**STAFF REPORT  
KETCHUM PLANNING AND ZONING COMMISSION  
MEETING OF SEPTEMBER 15, 2020**

**PROJECT:** Delong Townhome Design Review

**FILE NUMBER:** P20-051

**APPLICATION TYPE:** Design Review

4 SOUTH ELEVATION  
SCALE: 1/4" = 1'-0"

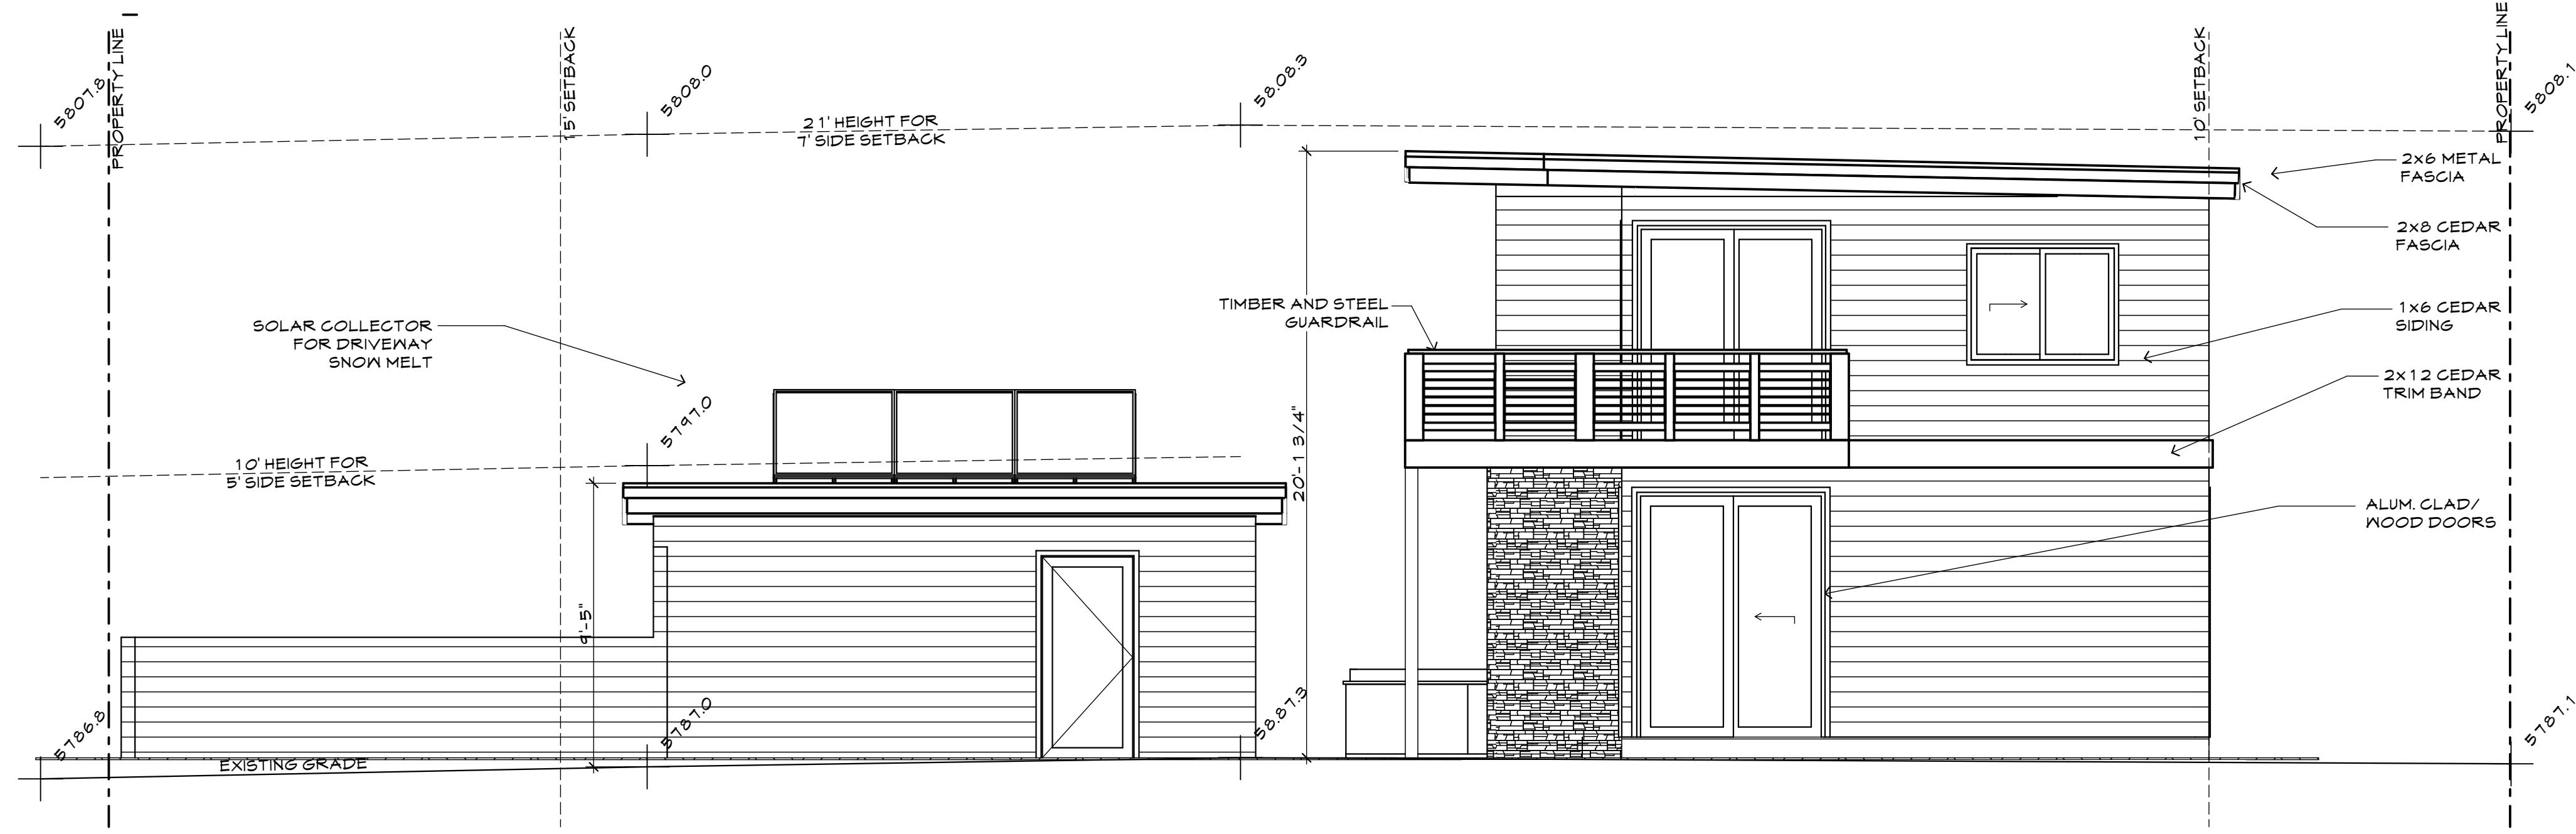
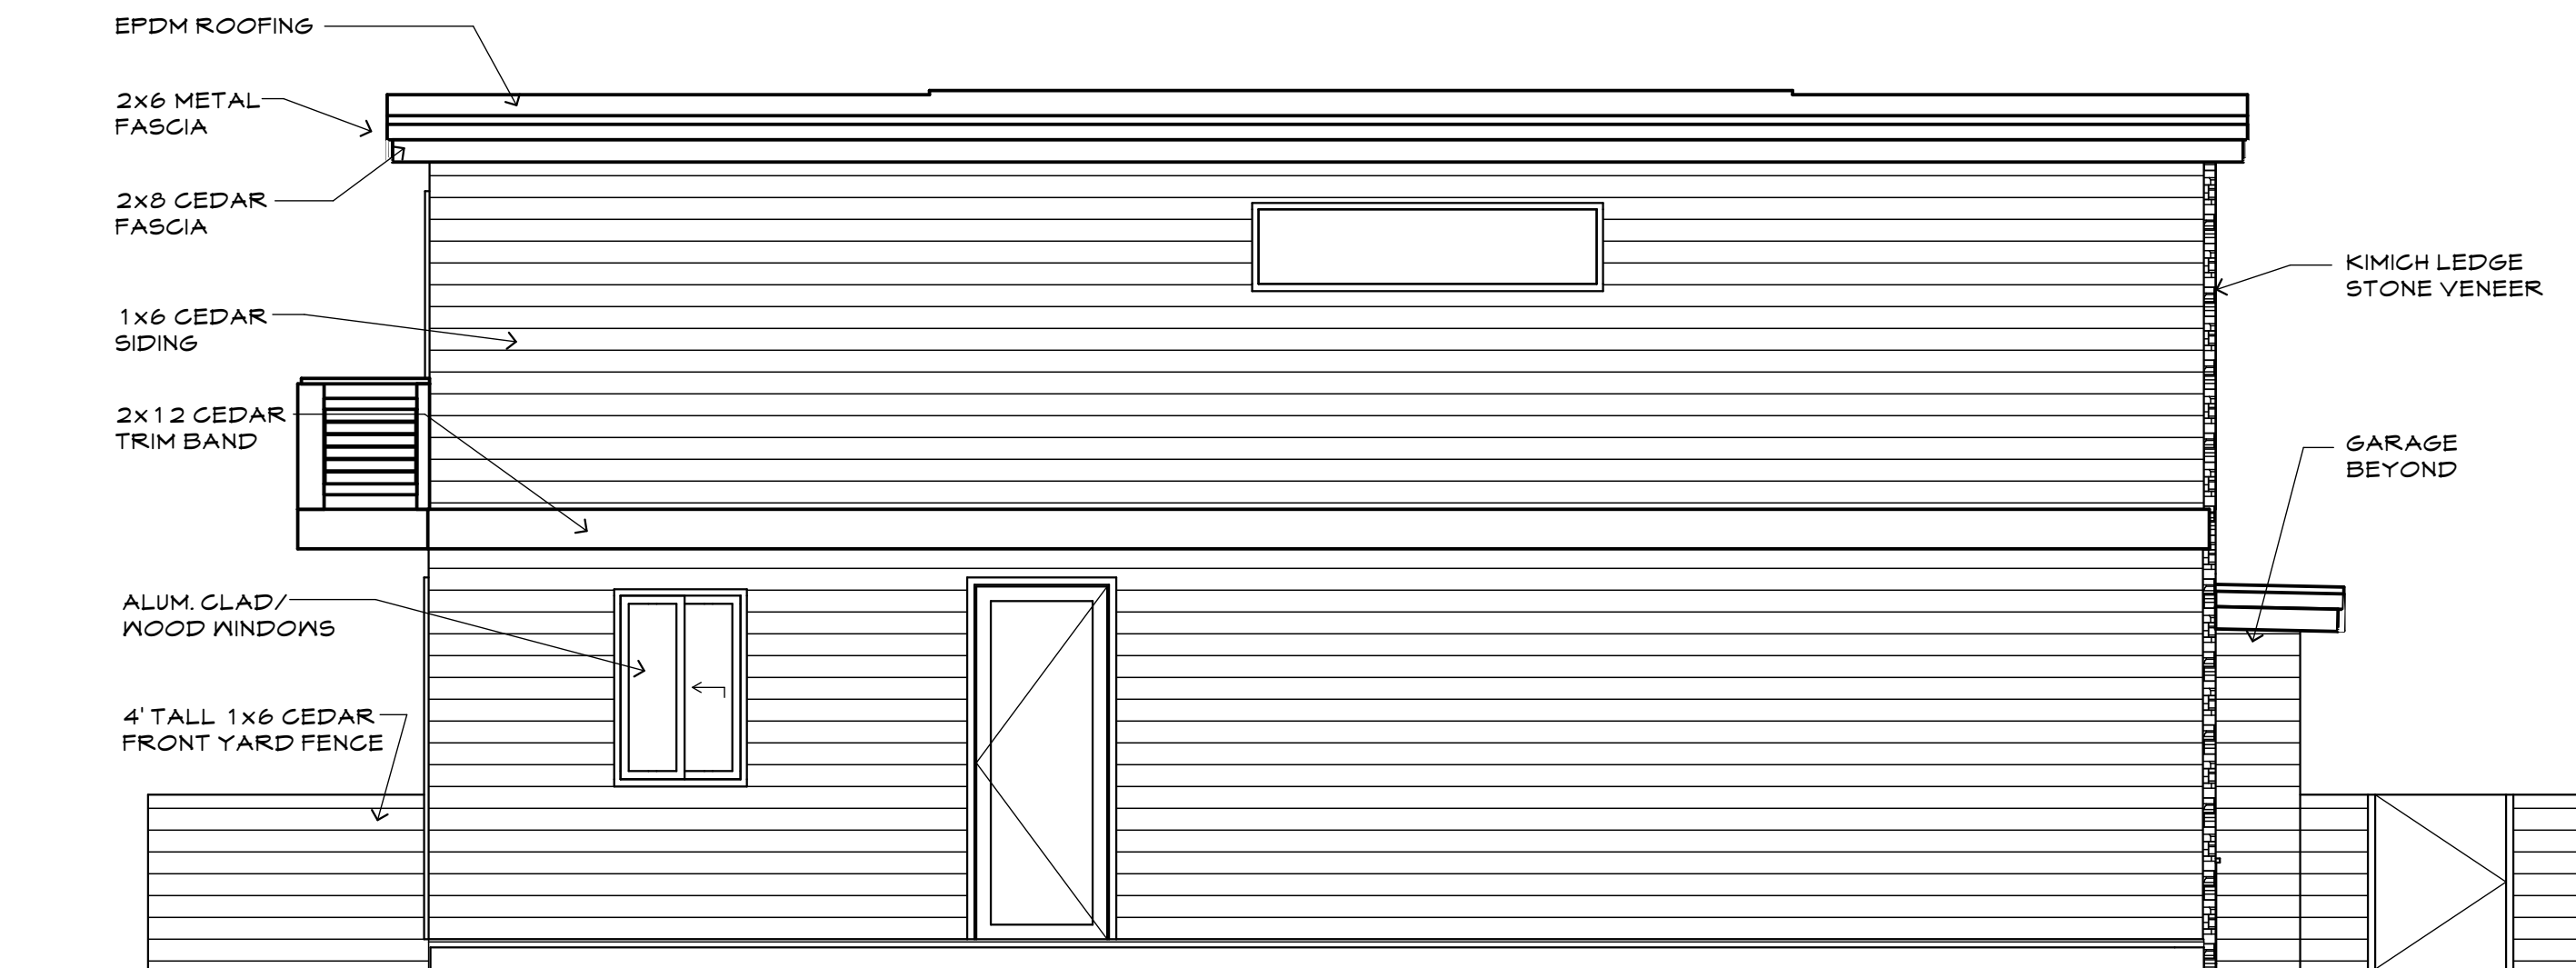
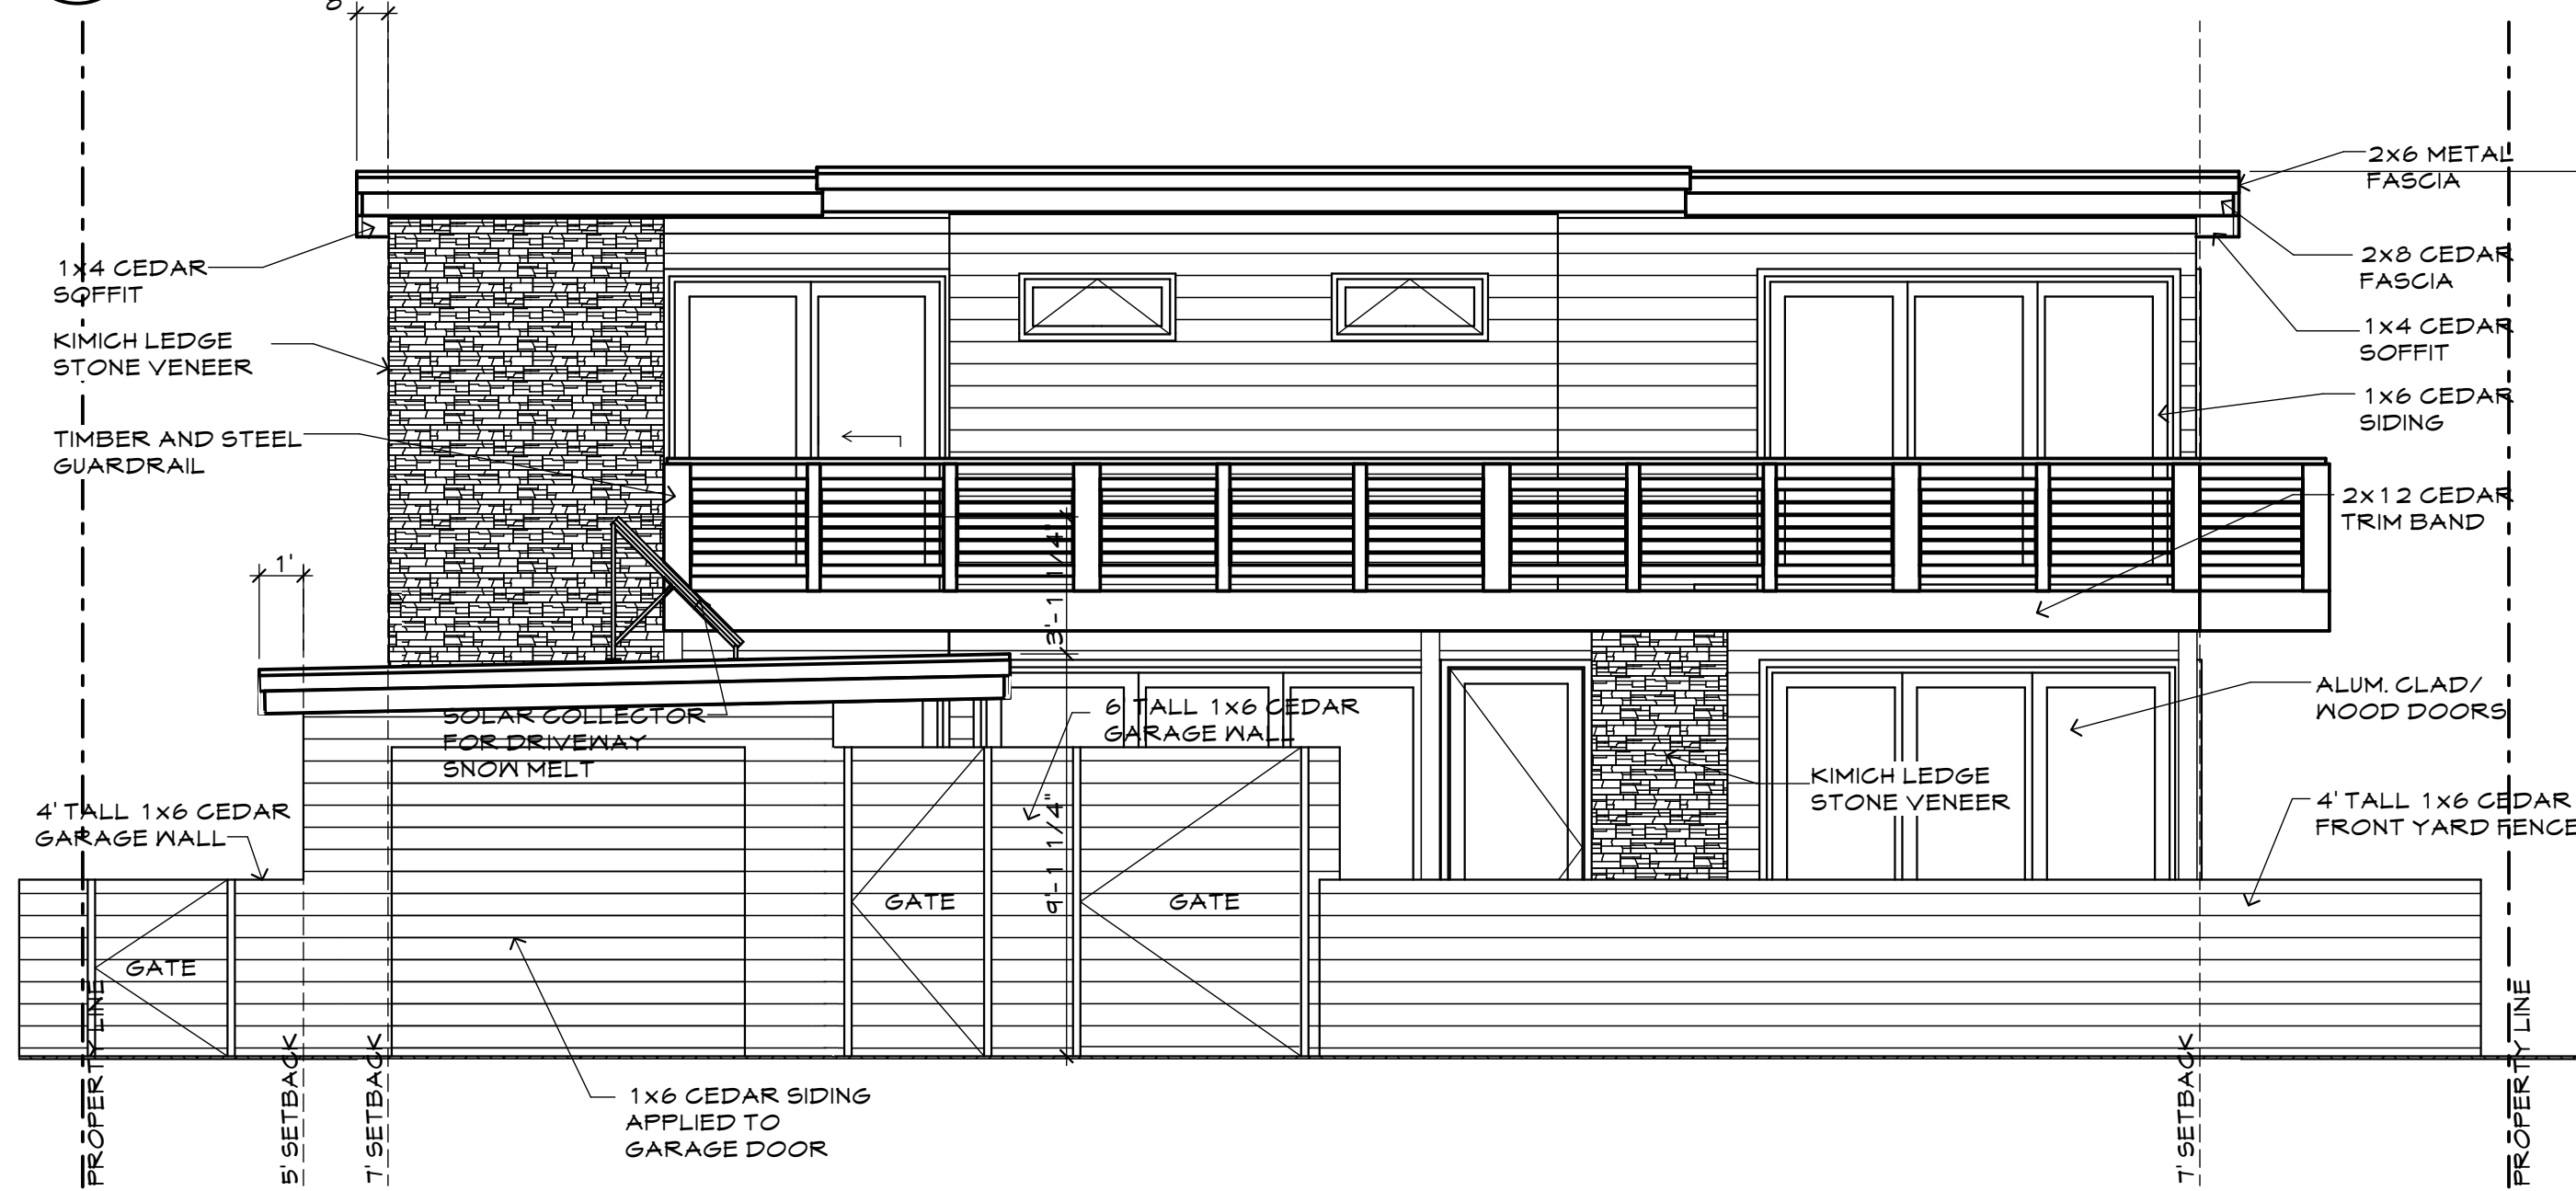
|                                     |                          |                                     | <i>Staff<br/>Comments</i>                           | <i>The elevations on Sheet 5 of the project plans note the exterior materials. The applicant has provided one colored elevation illustrating the front façade. Pictures and specifications of the proposed exterior materials have also been included in the project plans. The design utilizes natural materials and colors. The main material used across all facades of the townhome and garage is horizontal cedar siding stained with a natural tone. Two-story and one-story elements of stone veneer provide relief from the horizontally placed siding. The two-floors of the townhome unit are visually distinguished by the second-level balcony at the front elevation and a cedar trim band that wraps across all facades. Black aluminum-clad window and door openings, metal fascia, and the balcony's railing detail provide further relief from the horizontal cedar siding.</i><br><br><i>The neighboring townhome on subplot 2 is also characterized by natural materials and colors. The new townhome has a darker color palette with predominately reddish-brown stained cedar and black trim. The existing townhome has a lighter color palette with gray-tinted beige stone veneer and khaki-tan stucco with dark brown vertical siding and trim.</i><br><br><i>The project's materials and colors complement the adjacent homes and surrounding neighborhood. Homes in the surrounding</i> |

|                                     |                          |                                     | <i>Staff<br/>Comments</i>                           | <i>Building elevations are included on Sheet 5 of the project plans. Two-story and one-story elements of stone veneer provide relief from the horizontal cedar siding. The two-floors of the townhome unit are visually distinguished by the second-level balcony at the front elevation and a cedar trim band wrapping across all facades. Black aluminum-clad window and door openings, metal fascia, and the balcony's railing detail provide further relief from the horizontal cedar siding. The slight slope of the mono-pitched roof decreases the bulk of the box-shaped building.</i> |

|                                     |                          |                          | <b>Staff Comments</b>             | <p>The front and side façades incorporate material differentiation and visual relief from the bulk of the rectangular-shaped building. Two-story and one-story elements of stone veneer provide relief from the horizontal cedar siding. The two-floors of the townhome unit are visually distinguished by the second-level balcony at the front elevation and a cedar trim band wrapping across all facades. Black aluminum-clad window and door openings, metal fascia, and the balcony's railing detail provide further relief from the horizontal cedar siding. The slight slope of the mono-pitched roof decreases the bulk of the box-shaped building.</p> <p>The back wall is stark compared to the front and side elevations with only the cedar trim band, two windows, and one door opening. The existing townhome on subplot 2 is 23'-8" tall and will block this flat façade from public view.</p>   |

|   |   |   | <i>Staff Comments</i>              | <p><i>The second-level balcony extends beyond the front wall to cover the paver pathway leading to the front door. The flat roof form will prevent water from dripping or snow from sliding from the building. As noted on the east elevation (Sheet 5), the flat roof will be an EPDM system.</i></p>  |
